Sundry Print Report
01/08/2025

Well Name: POKER LAKE UNIT 13-24 Well Location: T24S / R29E / SEC 13 / County or Parish/State: EDDY /

Type of Action: APD Change

Procedure Description: **Surface hole Change, First and Last Take Point Changes, Bottomhole Location Change, Drilling Plan Change, Casing/Cement Change XTO Permian Operating, LCC. requests permission to make the following changes to the original APD: No Additional Surface Disturbance SHL: fr/2345'FNL & 830'FEL to 2420'FNL & 996'FEL, NMNM05912 FTP: fr/2740'FNL & 330'FEL to 1920'FNL & 336'FEL, NMNM05912 LTP: fr/330'FSL & 330'FEL to 330'FNL & 336'FEL, NMLC0696005A BHL: fr/200'FSL & 330'FEL to 280'FNL & 336'FEL, Section 1-T24S-R29E NMLC0696005A Additionally, XTO Permian Operating, LLC. respectfully requests permission to upsize the surface, intermediate and production hole, casing, and cement based on the attached drilling program. Due to the upsize in these strings, the wellhead configuration has also changed based on the attached drilling program. Casing/Cement design per the attached drilling program. Attachments: C102 Drilling Program MBS Directional Plan

ACREAGE DEDICATION PLATS

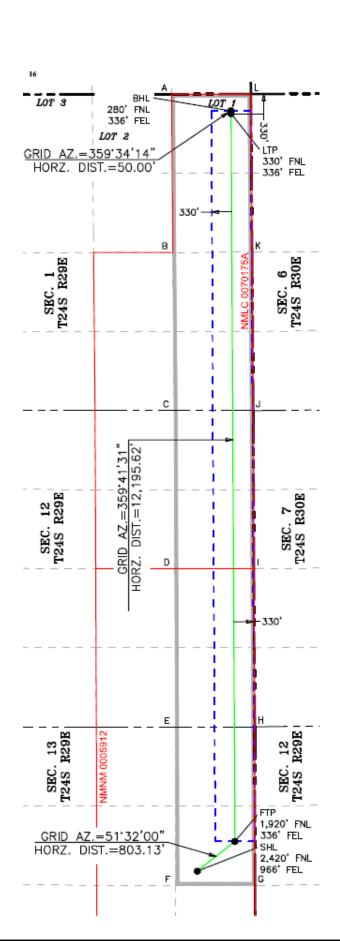
PROPOSED HSU IS NOT APPROVED - Dean McClure

Created By		Condition Date
dmcclure	The Proposed HSU is NOT approved. In the event that a NSP is granted for the proposed HSU, the operator shall submit a change of plans to amend the standard HSU to the non-standard HSU approved in the NSP.	3/10/2025
dmcclure	If cement is not circulated to surface during cementing operations, a Cement Bond Log (CBL) is required.	3/10/2025
